V02 Siboor Kit Review

By Greg's Maker Corner

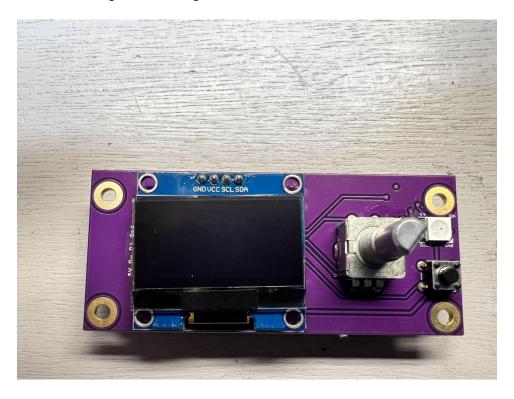
Metal shavings found in the hot end - nozzle was on too tight to do anything to clear it out.

I don't plan on using the included hot end because of the metal shavings. It makes me suspect the hot end may not be high enough quality, and will cause jams and problems. I have a spare dragon fly hot end and will just use that. I think it be good to revisit the hot end and double check the quality.

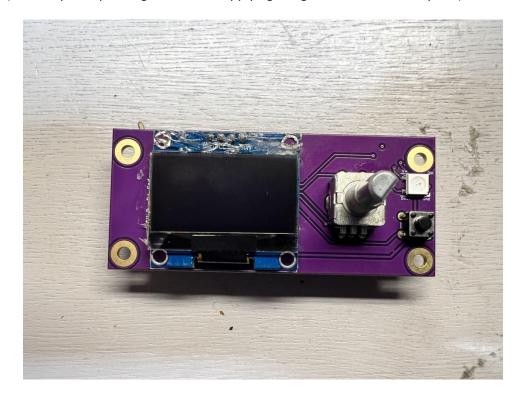
- The Voron 0 display had an angled screen on it. I was able to adjust it and used hot glue to hold it in place so it would be at the proper orientation. An improvement for the factory would be to double check these are glued properly.

The screen on the PCB was glued at an angle:

After fix: (Manually manipulating screen, and applying hot glue to hold screen square):
